# Product Change Notification

## 108150 - 01

**Change Notification #:** 108150 - 01  
**Change Title:** Intel(R) IP Network Server, PCN 108150-01, Product Design, Remove gasket from IO filler assembly, Reason for Revision: Post TA Revisions  
**Date of Publication:** June 27, 2008

TS000237

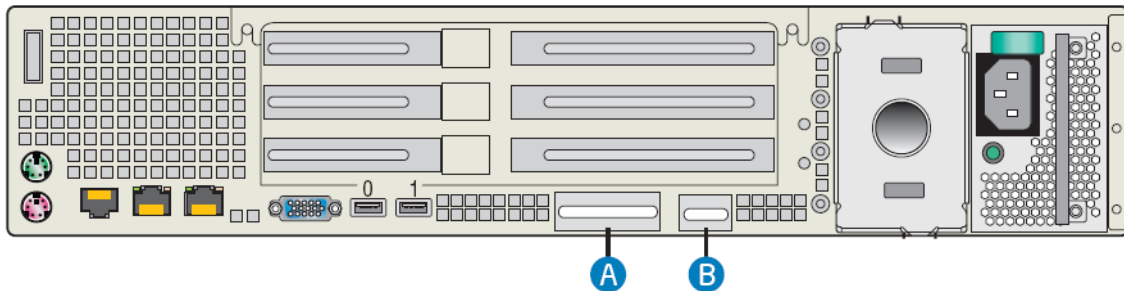
We removed the gaskets from the option module fillers (labeled "A" & "B" below) because the gasket is not required to pass the EMI scan. The gasket was located on the bottom surface of the stainless steel filler.

There is no anticipated impact to the customer. The recommendation is to use the gasketed or non-gasketed option fillers as shipped on the chassis.
